**DIKES AND REVETMENT CONSTRUCTION/REPAIR  
REPORT OF AS-BUILT CONDITIONS**

Contract Description: QJM FY14 MRM-195<sup>300</sup> Contract No.: W912P9-14-C-0411

River Mile: 258.46 Type of Structure (Constructed/Repaired): WEIR

River Mile: 258.3L Type of Structure (Constructed/Repaired): WEIR

**PROJECT INFORMATION**  
 PROJECT NO: W-1300-10  
 SHEET NO: C-107  
 TITLE: WEIR 258.4 L PLAN AND PROFILE

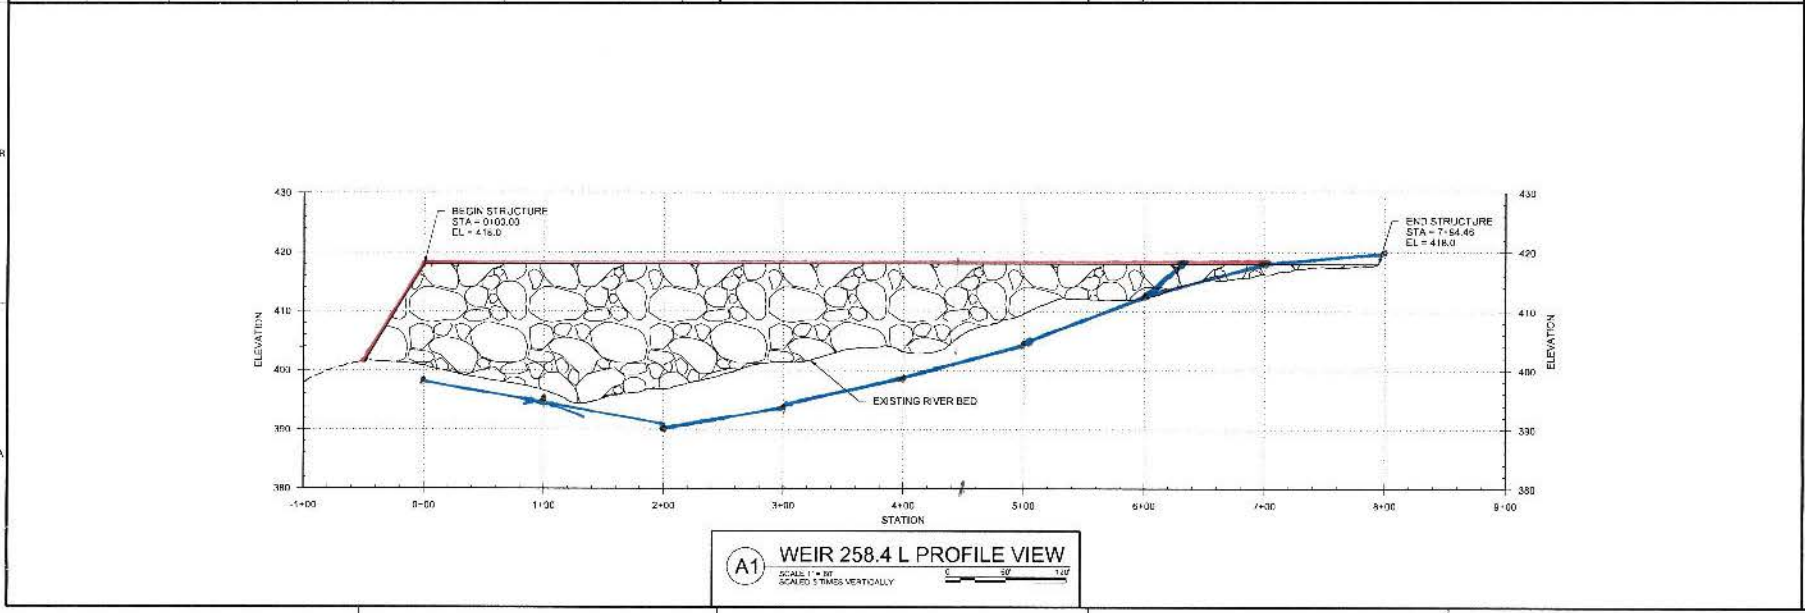
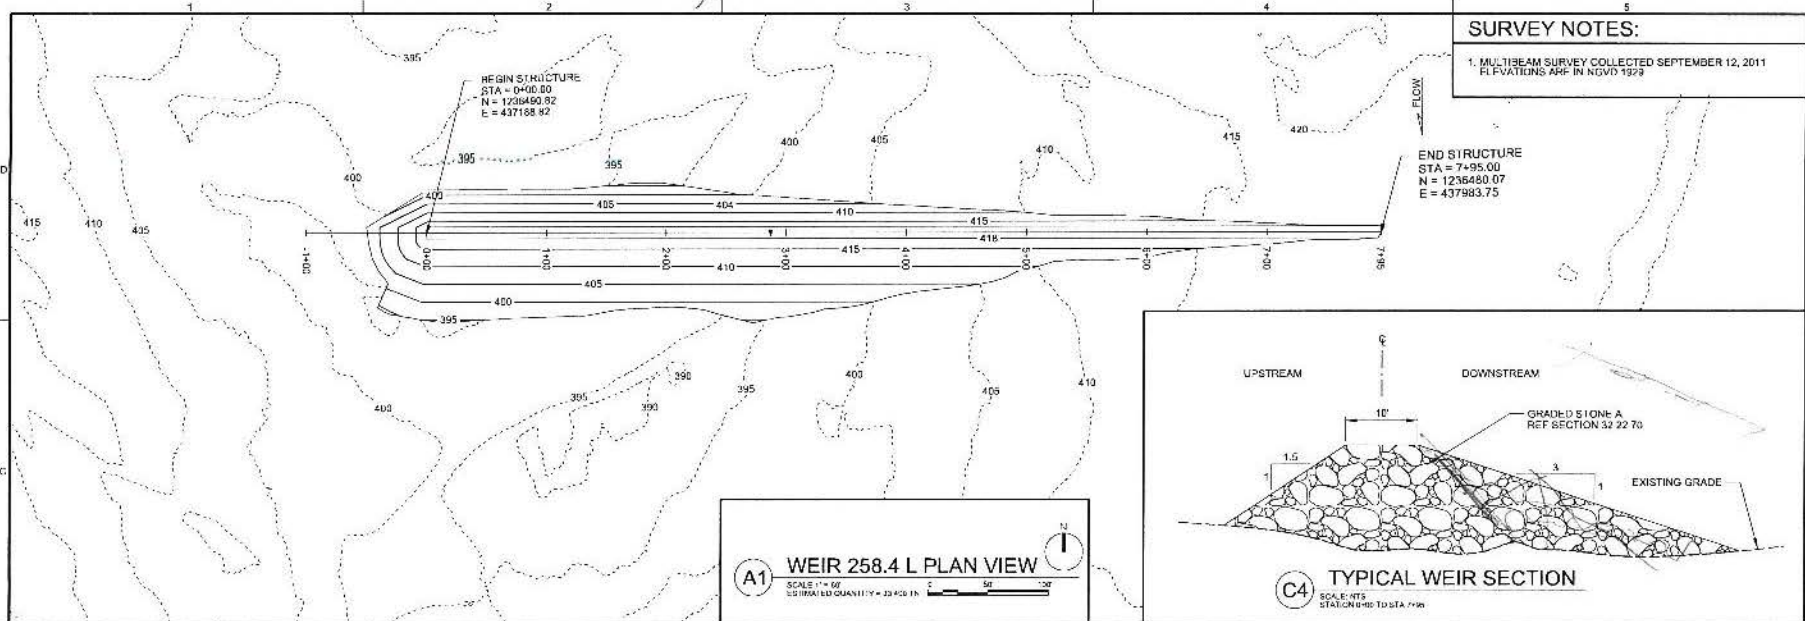
General remarks or unique conditions: cut the WEIR off at 6+30

due to the water being too shallow for fill

Length of Structure Completed or Repaired Performance Shown by Stationing: 630'

Station: 0+00 6+30

PROJECT: WEIR 258.3 L  
DRAWING: WEIR 258.3 L  
WEIR 258.3 L PLAN AND PROFILE

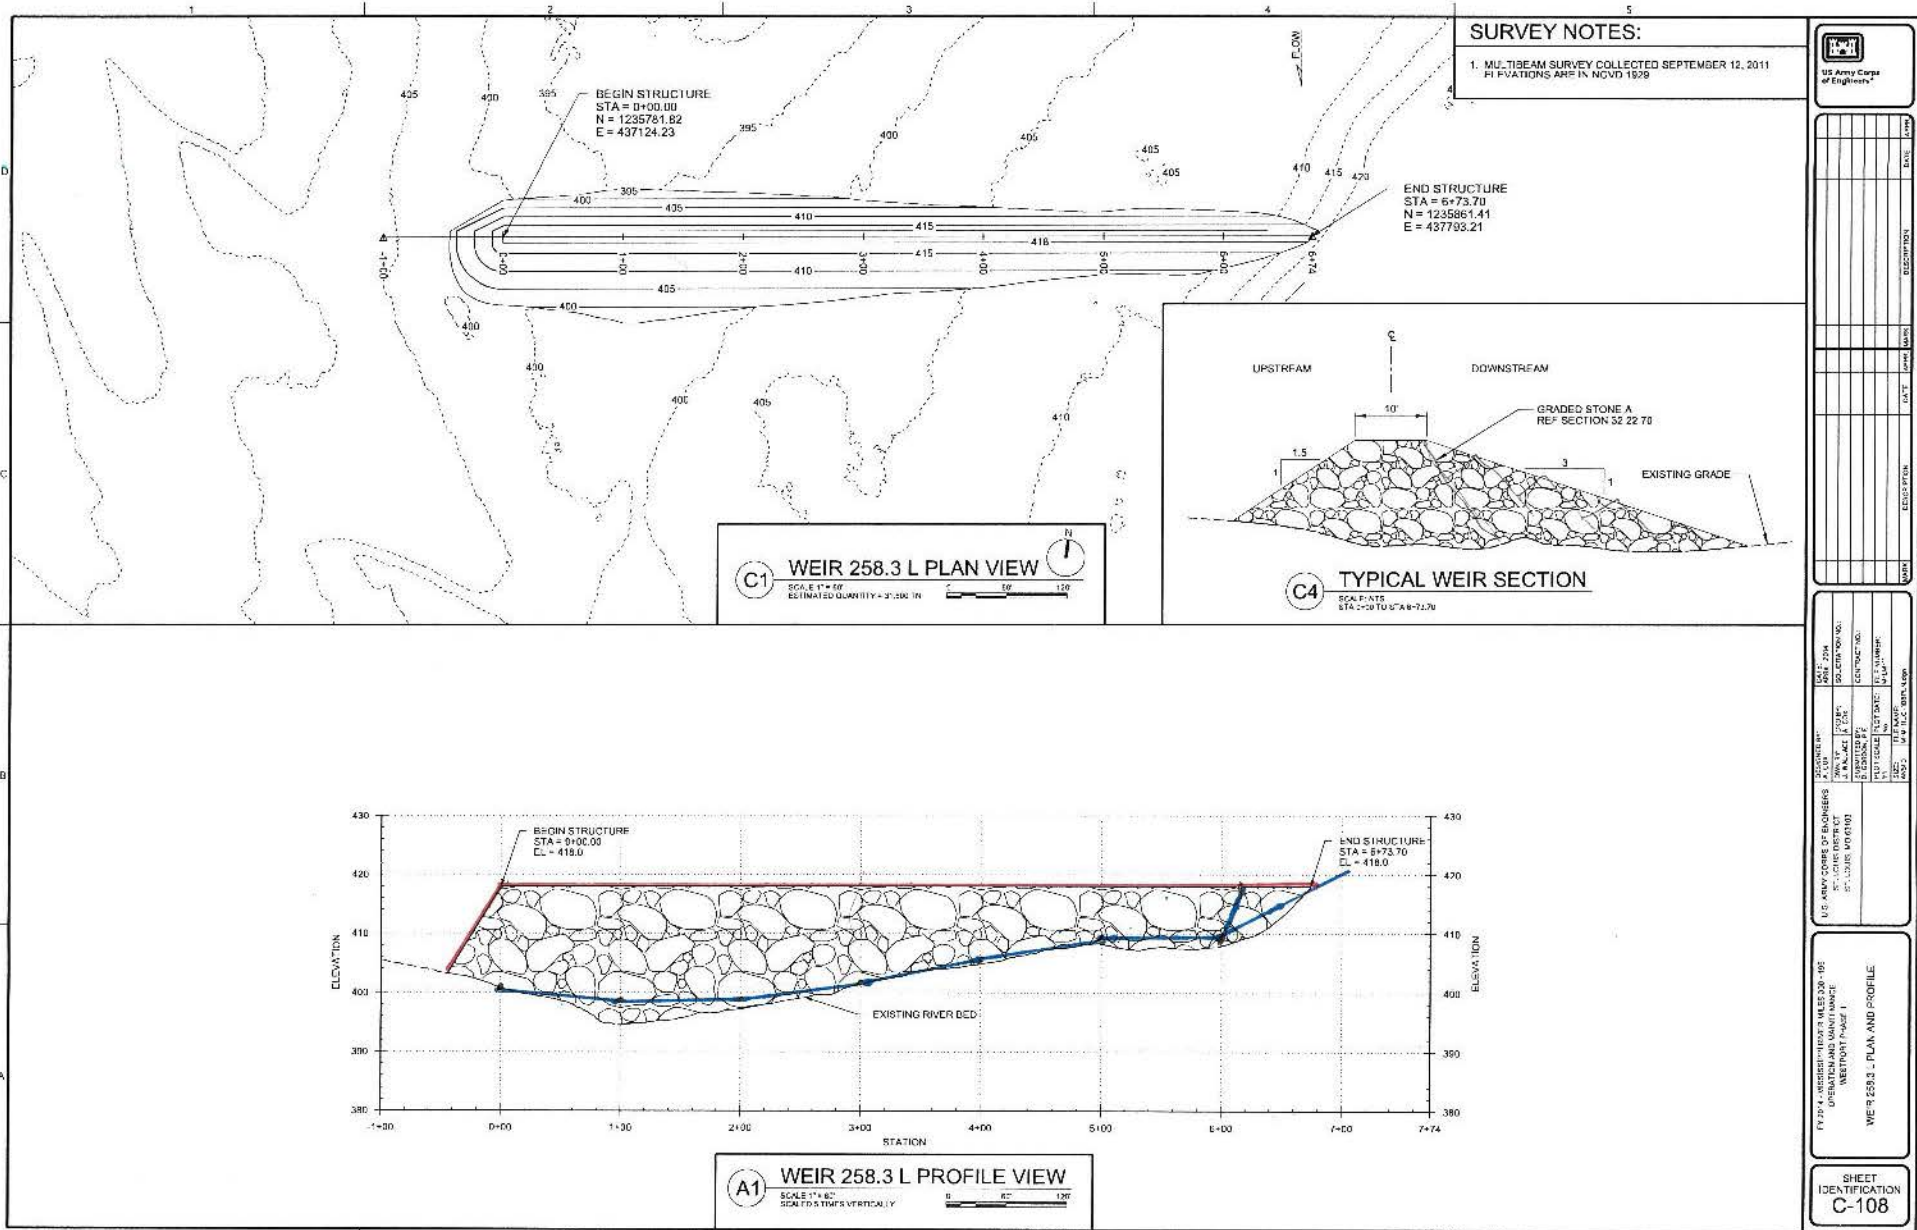
General remarks or unique conditions: cut the WEIR off at 6+10

due to the water being too shallow for fill.

Length of Structure Completed or Repaired Performance Shown by Stationing: 610'

Station: 0+00 - 6+10
